**DESCRIPTION: Malcolm C. Hursey Montessori School at Ron McNair Campus
School Building No. 0734**

ITEM 1		No. of Pages
	1. ADD Questions and Clarifications	3
	2. ADD Specifications	6
	3. ADD Drawing Changes	6
ITEM 1.1	QUESTIONS & CLARIFICATIONS: See the attached clarifications indicating changes to be incorporated into the Contract Documents.	
ITEM 1.2	SPECIFICATIONS: In accordance with this addendum, the following specifications shall be incorporated into the Contract Documents	
	1. Section 016400 Owner Furnished Products	
ITEM 1.3	DRAWINGS: In accordance with this addendum, the following drawings shall be incorporated into the Contract Documents:	
	1. Sheet G1.02	
	2. Sheet C501	
	3. Sheet L2.01	
	4. Sheet L2.03	
	5. Sheet A1.04a	
	6. Sheet A6.14

END OF ADDENDUM No 2

8 COUNTER FLASHING DETAIL
6" = 1'-0"

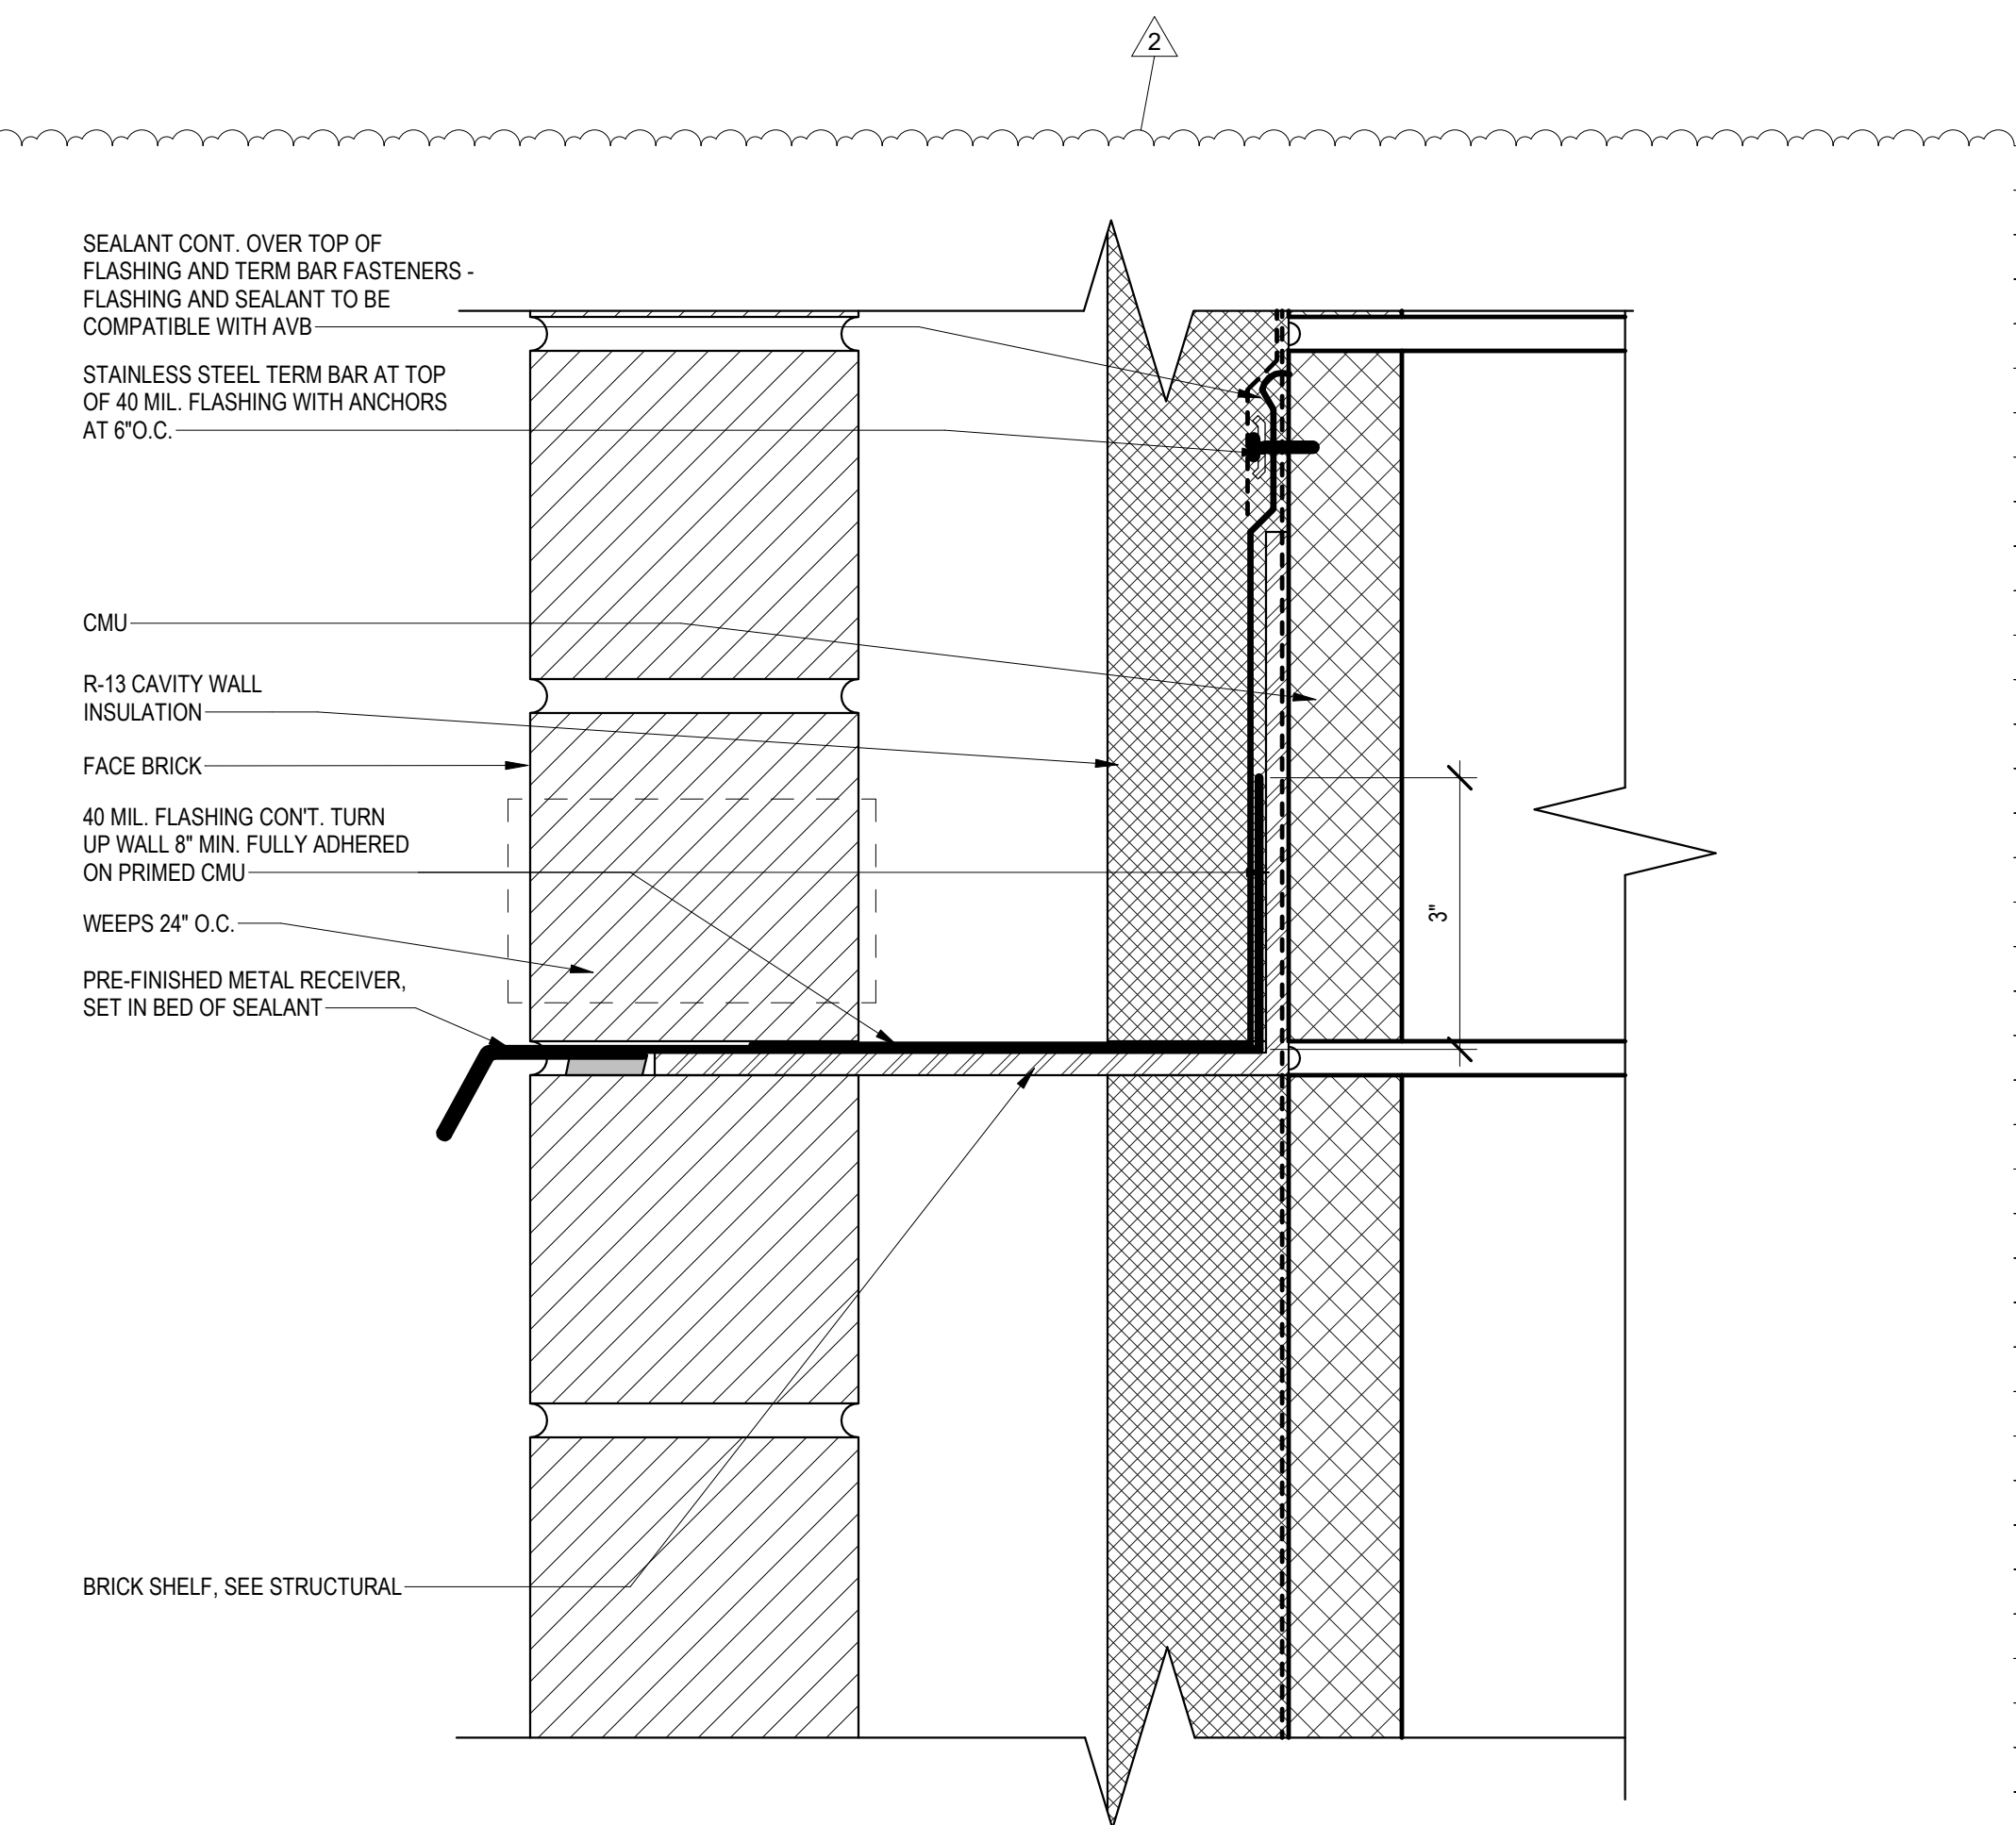
- A2.11 **No, markups are to be included in the base bid cost.**
- Q2.11 The structural drawings show bent plate brick relief angle on second and third floor on detail 2/S1.12a. This is not shown on architectural. Is flashing, weeps, expansion pads and/or caulking required at these locations?

5. A1.04a OVERALL ROOF PLAN
Revisions to required fire ratings near 3-Hr wall.
6. A6.14 EXTERIOR DETAILS
Added counterflashing detail

- A2.11 **Yes, that would be a standard requirement at all brick relief angles. See detail 8/A6.14.**
- Q2.12 The retaining wall is extremely close to the adjacent land? How will this be built without encroaching on the adjacent property?
